Access Compliance Report Public Rights-of-Way (Curb Ramps)

Main Street: FOSTER_RD Cross Street: TIGERTAIL_DR Location: SW

ADA ID: RPRK211207125339 Ramp Type: Type 1 - Perpendicular Diagonal Initial Pass/Fail: Pass Overall Compliance: No Severity Score: 5

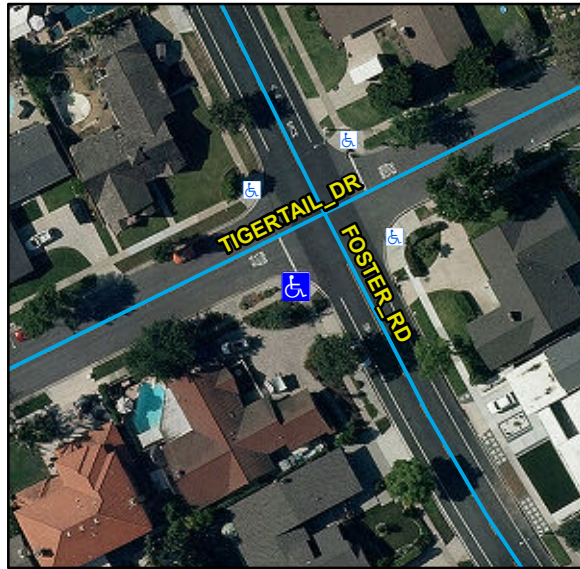
N/A	Ramp Inside Crosswalk 1	N/A	Yes	Ramp Inside Crosswalk 2	N/A
	Crossing 1 Slope (%)	11		Crossing 2 Slope (%)	4.7
	Crossing 1 Cross Slope (%)	5.4		Crossing 2 Cross Slope (%)	1.4
Yes	Gutter Ponding	No	No	Curb Slope	7.2
Yes	Gutter Lip Height (in)	0		Road Run Slope (%)	2.6
No	Gutter Run Slope (%)	5.6		Road Cross Slope (%)	8.9
No	Gutter Cross Slope (%)	3.7			
Yes	Overall Surface Condition: Acceptable		Yes	Perp Joint Present	Yes
	Cross Gutter Present?	No		Spandrel Present?	No
	Replace Cross Gutter?	N/A		Replace Spandrel?	N/A

Remove & Replace Curb Slope. Remove & Replace Gutter.

R304.2.2, R304.5.4, R304.5.3, STD 1115
